UNITED STATES PATENT AND TRADEMARK OFFICE

APPLICATION NO.	FILING DATE	FIRST NAMED INVENTOR	ATTORNEY DOCKET NO.	CONFIRMATION NO.
10/633,295	07/31/2003	Jeffrey H. Wood	BOI-0259US	3327
60483	7590	11/01/2006	EXAMINER	
LEE & HAYES, PLLC 421 W. RIVERSIDE AVE. SUITE 500 SPOKANE, WA 99201			LE, TAN	
			ART UNIT	PAPER NUMBER
			3632

Office Action Summary

DETAILED ACTION

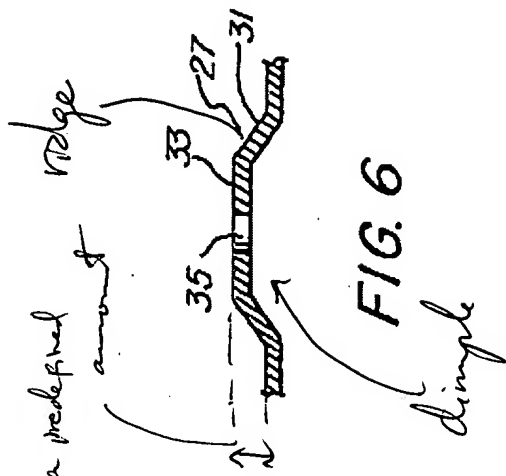
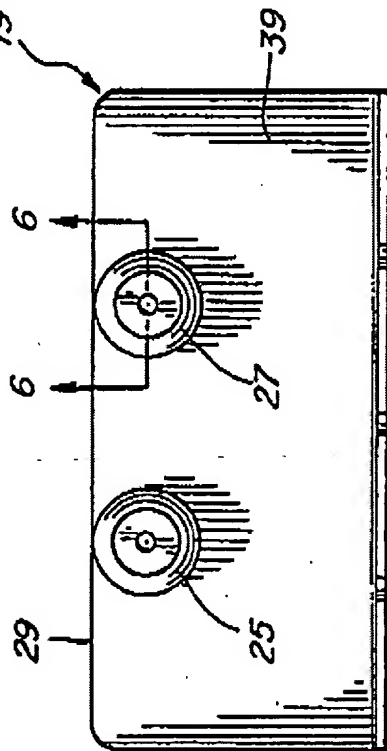
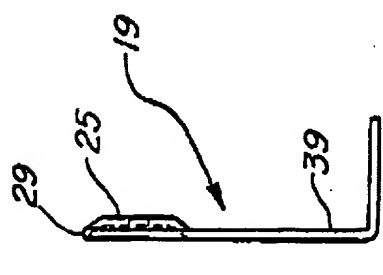
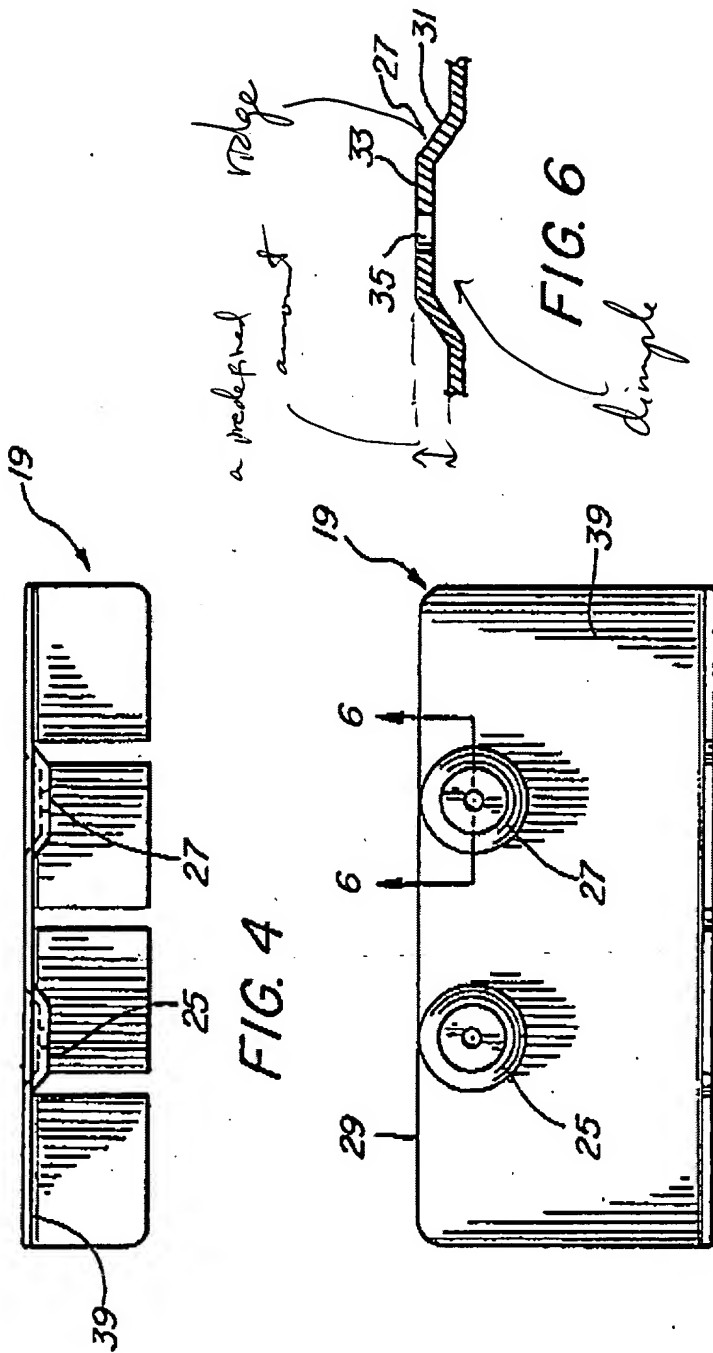
As to claims 1-2 and 27, Dragovic teaches a bracket (see Fig. 2-7, for example) substantially as claimed which comprises a first portion (21); a second portion (23) wherein a second portion includes a plurality of separation features (25, 27) (Fig. 3), the separation features including at least one of dimples and ridges (see attached Figure 6), the separation features maintain separation by a predetermined amount. Dragovic also teaches an adhesive tape adhering between the second portion and the support structure, therefore the size of plurality of separations features is inherently based on an amount of adhesive (37).

As to claims 4 and 12, Dragovic also teaches the separation feature including a plurality of dimples (see Fig. 6) and the bracket can be either formed by one of molding or extruding (see Col. 2, 25-29).

In response to Applicant's argument that Neither Dragovic nor Hara (Note that the examiner will not use the reference of Hara at this time, therefore argument on Hara is moot) discloses that dimples or ridges are sized based on an amount of adhesive use in adhering a second portion to a support structure" ((page 13 of the Remarks). The examiner respectfully disagrees with this argument: (a), the phrase such as "are sized or configured based on an amount of adhesive used in adhering a second portion to a structure" is merely an intended used functional expression which does not defined any structure and accordingly can not serve to distinguish and thus could not have patentable significance; (b), "the size of the plurality of separation features is *based on an amount of adhesive used in the process of adhering the second portion to the support structure*" is merely a product-by-process claim in an article /product/apparatus claim. It adds nothing and is not germane to the issue of patentability of the device itself. Therefore, this limitation has not been given patentable weight. It is well settled that the patentability of a product does not depend on its method of production. Product -by-process claims are not construed as being limited to the product formed by the specific process recited. In re Hirao et al., 535 F2d 67, 190 USPQ 15. In vie w of the above reasons, the examiner contends that the argument is not persuasive and the claims are therefore still rejected as being anticipated by Dragovic.
